# 汚水処理に関する調査研究（RSW）

（2005年度報告書）

財団法人 日本船舶技術研究協会

BLG 10/7  
23 December 2005  
Original: ENGLISH

[Figure 1: Suggested loading factors and sampling frequency for testing sewage treatment plants. May be modified as necessary to take account of characteristics of individual sewage treatment plants.]

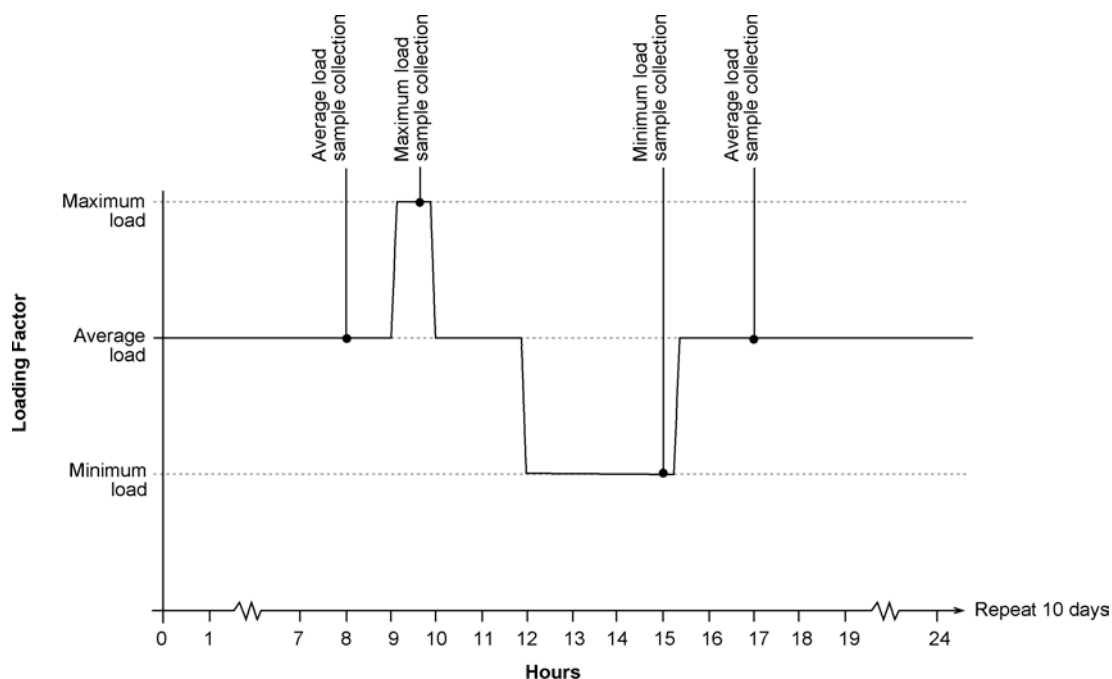
25 A recommendation for the sampling regime for testing ashore was incorporated into the guidelines through a diagram (Figure 1) based on current procedures used in Japan. Modifications have been made to Japan's original diagram to take account of the removal of 'zero loading' tests. In the final round of comments, one participant suggested that the period of operation at minimum load prior to minimum load sample collection be increased to 3-4 hours to better simulate operational conditions. An alternative diagram has been prepared and both have been contained in square brackets for BLG consideration (paragraphs 5.4.1.1 and 5.5.1 refer to Figure 1).

*Note to MEPC 54: there is a current proposal to amend this diagram to recommend a period of 3-4 hours of operation of the sewage treatment plant at minimum load before collecting the minimum load sample. The proponent considers this would better represent operational conditions of minimum load (e.g. night time). An alternative configuration for the Figure 1 is therefore presented below.*
